MIL-C-39012C
AMENDMENT 6
11 June 1993
SUPERSEDING
AMENDMENT 5
26 April 1991

MILITARY SPECIFICATION

CONNECTORS, COAXIAL, RADIO FREQUENCY,
GENERAL SPECIFICATION FOR

This amendment forms a part of MIL-C-39012, dated 11 August 1982, and is approved for use by all Departments and Agencies of the Department of Defense.

FIGURE 6. Safety wire hole pullout procedure.

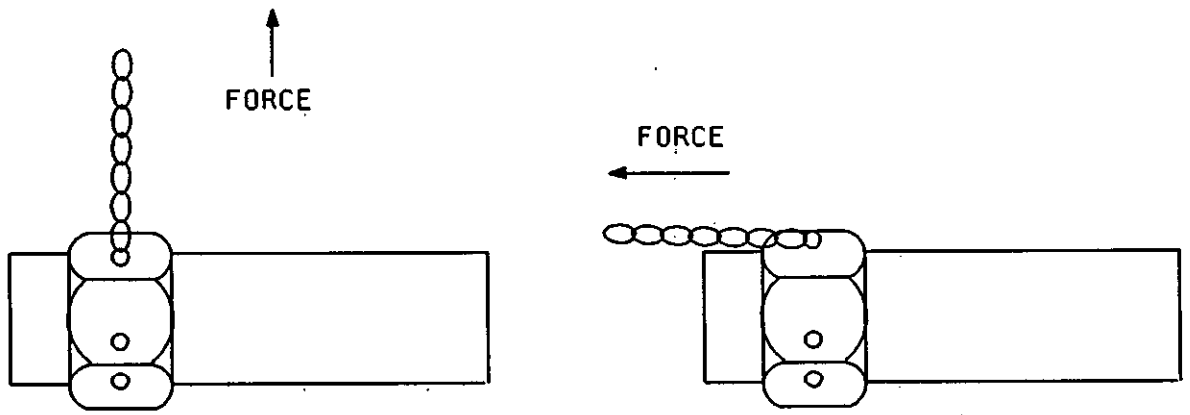
Add 4.6.25 as follows:

Add figure 6 as follows:

"4.6.25 Safety wire hole pullout (see 3.32). A single strand of safety wire shall be looped through the safety wire hole and secured to itself. Forces of 15 pounds (67 newtons) minimum shall be applied to the safety wire pulling away from the connector. One pull shall be parallel to the connector axis and one pull perpendicular to the connector axis (see figure 6). The safety wire shall be corrosion resistant steel .020 inch diameter (24 gauge) or .015 inch diameter, (27 gauge) in accordance with MS20995. This test is to be conducted under static conditions. All holes are to be tested individually."
